Re: Request for Hearing for Osve Dairy:
TPDES Permit No. WQ0003682000 (2402-4)

Please accept this letter submitted on behalf of my client, the Bosque River Coalition (the "Coalition"), a Texas non-profit corporation, consisting of property owners located in the vicinity of the dairy that is the subject of draft TPDES Permit No. WQ0003682000 (the "Draft Permit") for Joseph Osinga, Jennifer Osinga, Bert Velsen, and Heidi Velsen / Osve Dairy (hereinafter, the "Dairy" or "the Applicant"). The purpose of this letter is to request a contested case hearing regarding the Draft Permit. The Coalition also hereby requests that it be placed on the mailing list so that it may remain informed on the status of the Draft Permit.

ATTACHMENT 1

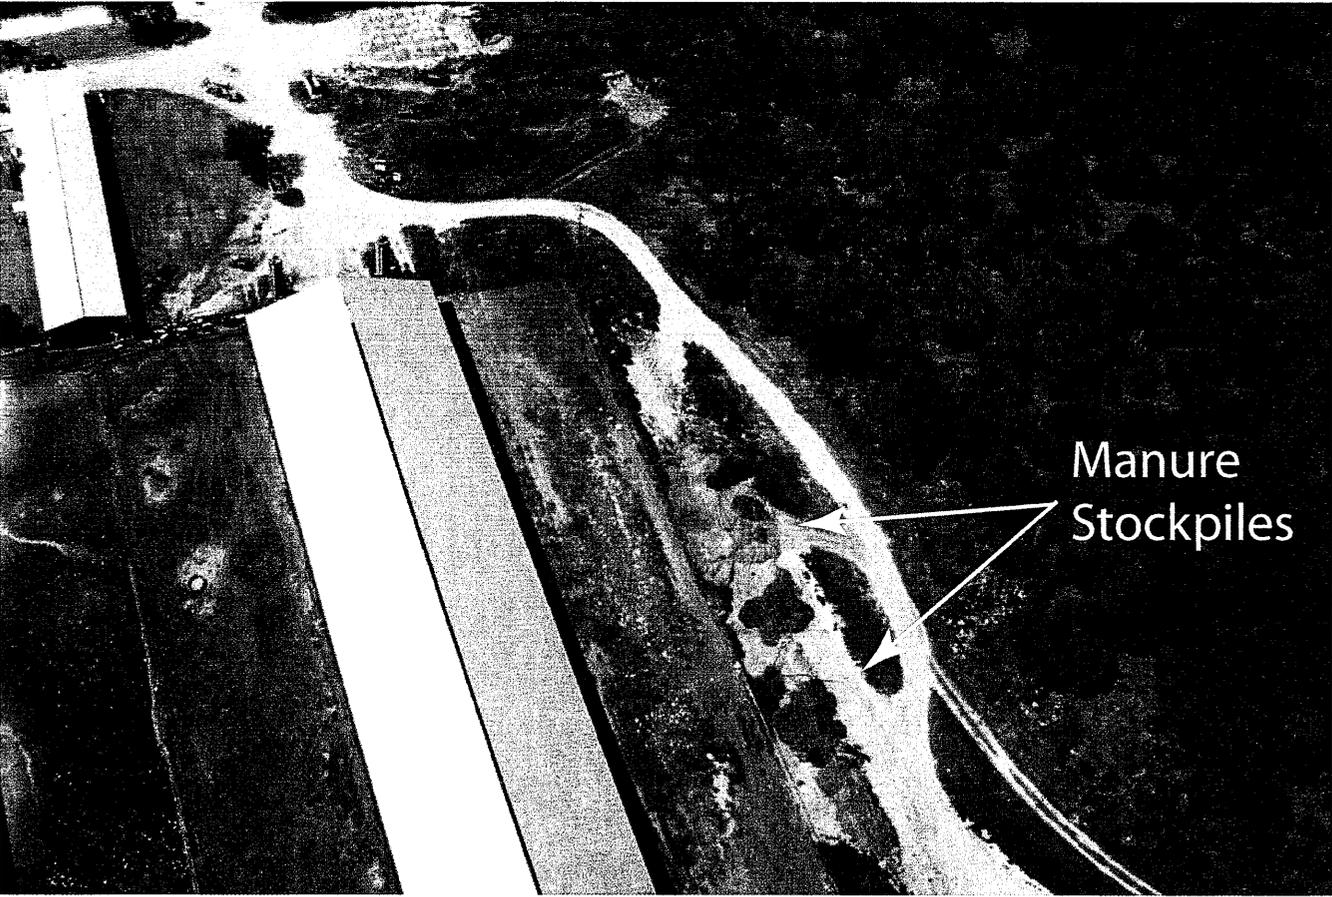
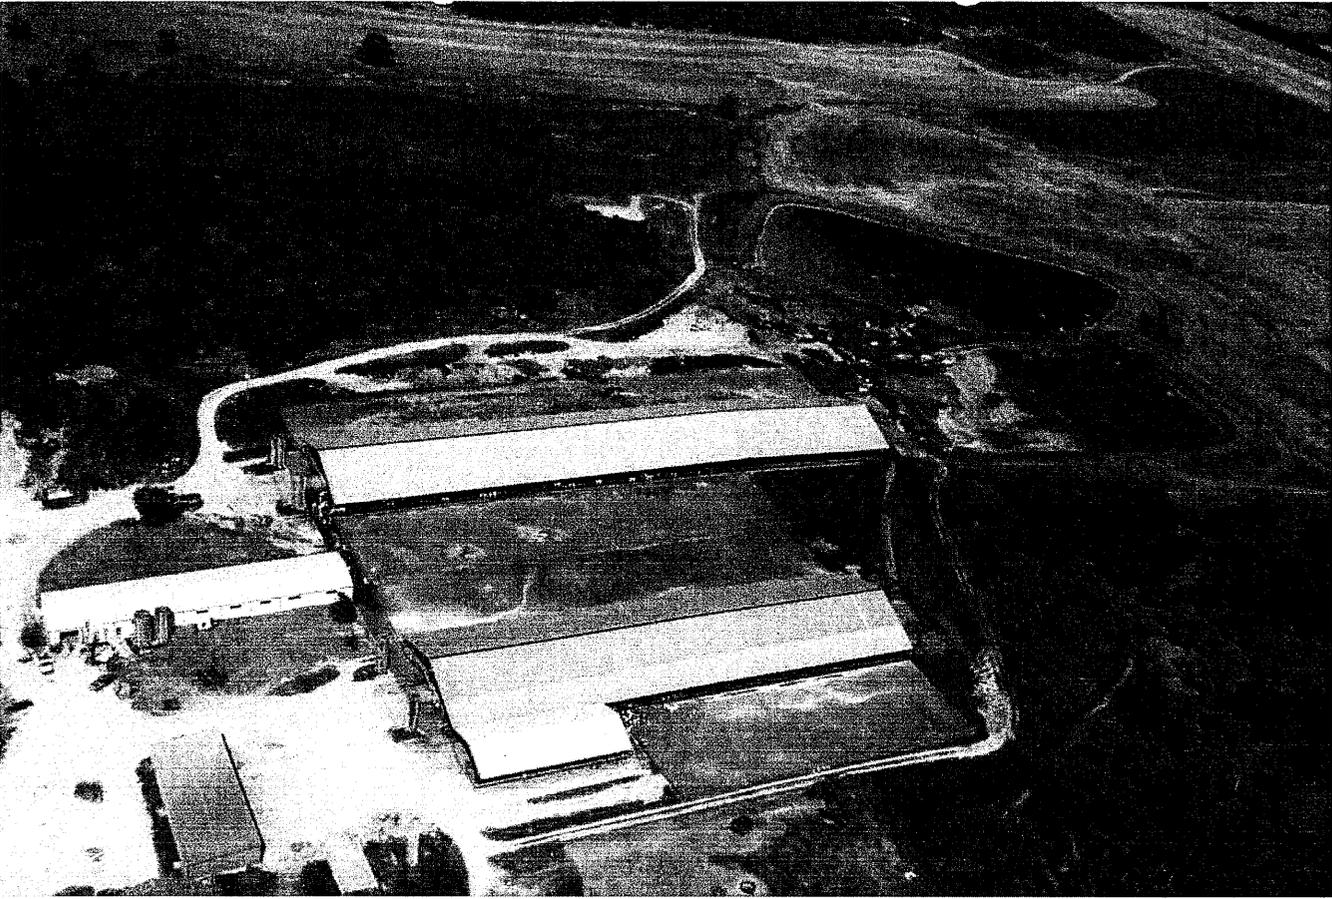
Sludge accumulation in the existing RCSs is probably so great that they no longer can maintain the minimum treatment volume or contain even the 25-year 24-hour rainfall event. The capacity certification for RCS Nos. 1 and 2, sealed December 28, 2002, indicates that no sludge accumulation has occurred. The capacity certification for RCS No. 2, sealed December 28, 2002 shows sludge accumulation exceeding the capacity reserved for sludge. Photos of RCS No. 1 and RCS No. 2, taken on May 28, 2008, seem to demonstrate that each RCS suffers from obvious sludge accumulation, to the level that their respective capacities have been significantly

reduced.² RCS No. 1 most likely cannot maintain the minimum treatment volume in its May 2008 condition. And the combined capacity of the RCS No. 1 and No. 2 will, in all probability, be insufficient to contain runoff from a 25-year 24-hour rainfall event. The capacity certification for RCS No. 3, sealed June 2, 2003, indicates a sludge accumulation of over 20 percent of the total as-built capacity. Given the amount of time that has elapsed since this capacity evaluation was conducted, it is quite possible that RCS No. 3 no longer has adequate capacity. The TCEQ should require the applicant to conduct a new capacity certification, including a calculation of sludge accumulation, before the Draft Permit is issued.

ATTACHMENT 2

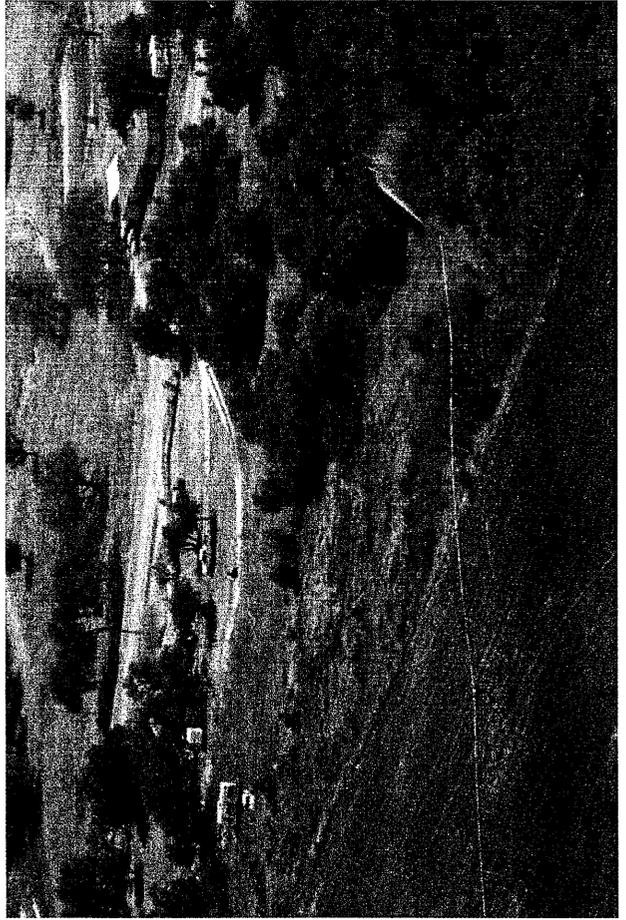
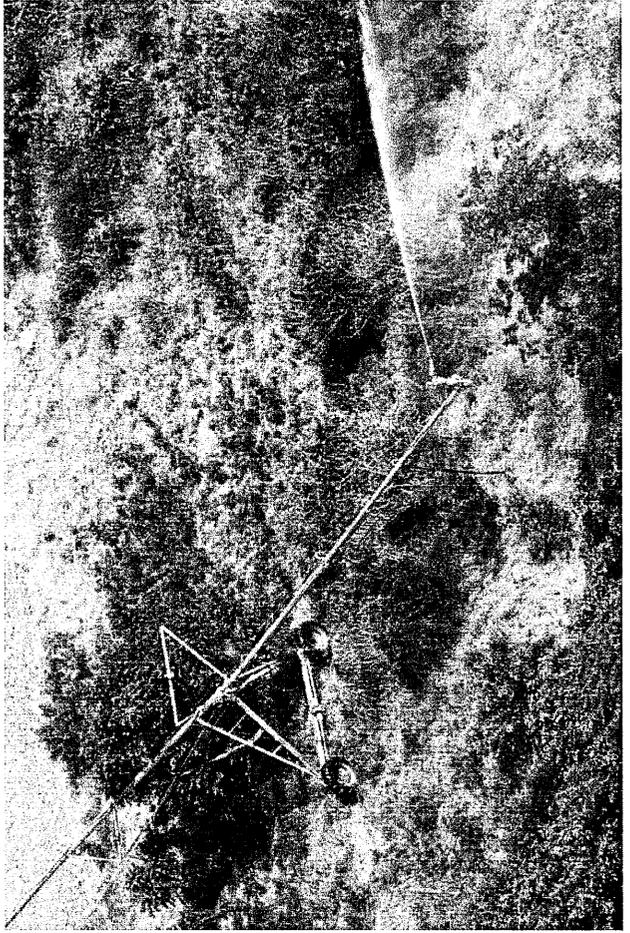
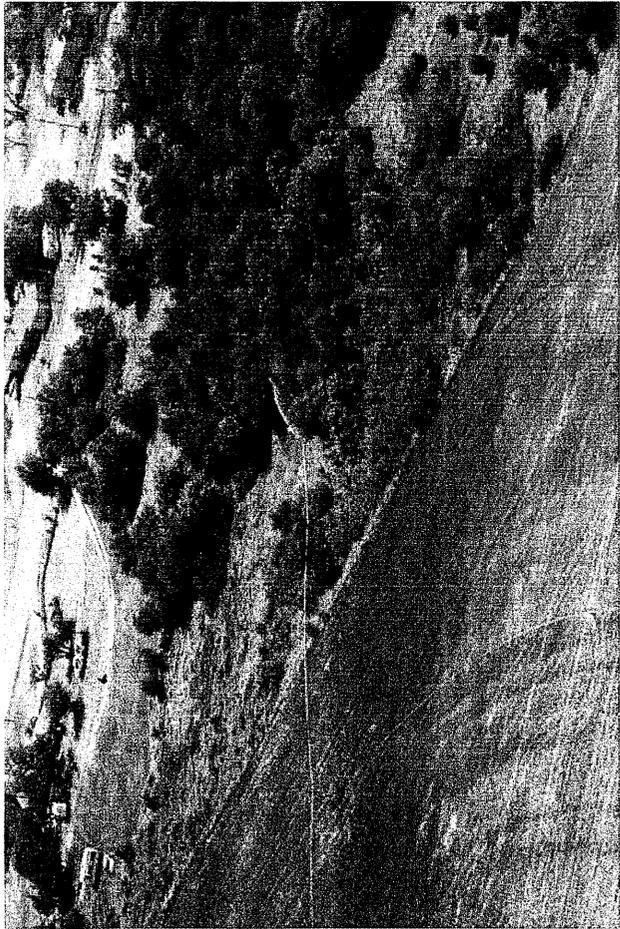
The site map shows the location of only two pen areas. A review of recent aerial photos of the current facility shows that there are other pen areas that should have been included on the site map.⁴ The pens and open lot areas should be clearly identified on the site map. Likewise, so that the areas used in the drainage calculations can be confirmed, the site map should also show the adjacent areas (including specification of ground cover) between the pens and control structures. Without showing and labeling these areas on the site map, inspectors are likely to have much difficulty verifying the adequacy of ground cover during their field inspections. Without adequate ground cover, of course, the assumptions made in the application will be unreliable.
